CITY OF ALBUQUERQ

The Varela Residence Volcano Cliffs Unit 18 RE: 6505 Pato Rd NW, S.A.D. 228, Lot 21 Block 6 **Grading and Drainage Plan** Engineers Stamp Date 12/27/16 (D10D003M21)

Based upon the information provided in your submittal received 1/10/17, this plan cannot be approved for Grading Permit, until the following comments are addressed.

C-1.0

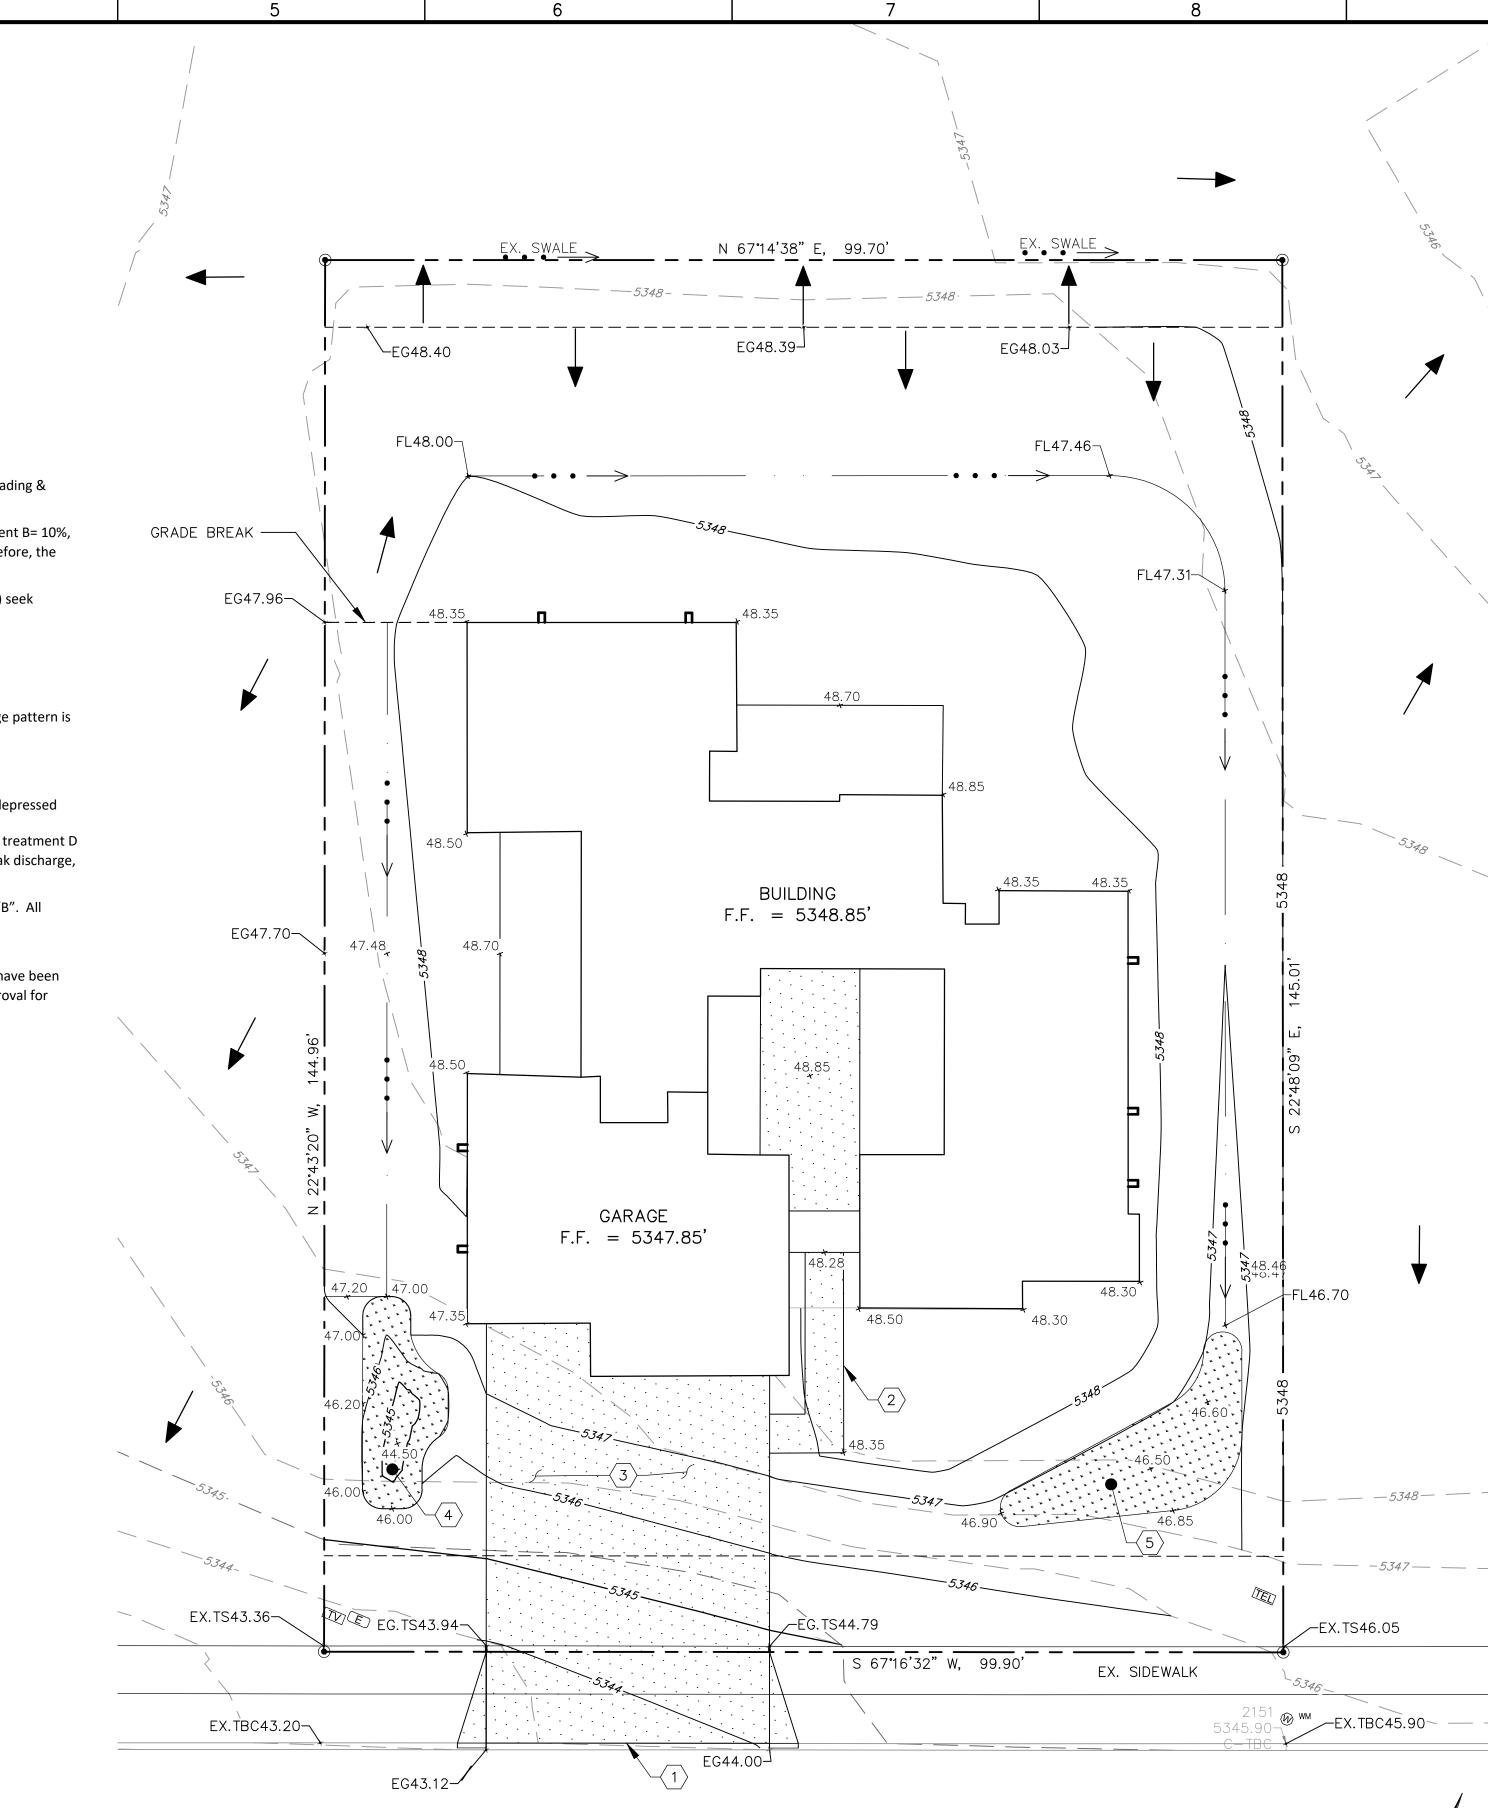
- Provide a statement requiring that a pad certification or a written statement by you is required before the home is released for building permit or the concrete pad is poured.
- Provide a statement informing the owner/contractor that a separate for a garden wall or retaining wall is required, and an opening 3" above grade is required for flows to pass through their rear yard according to the S.A.D. 228 master plan.
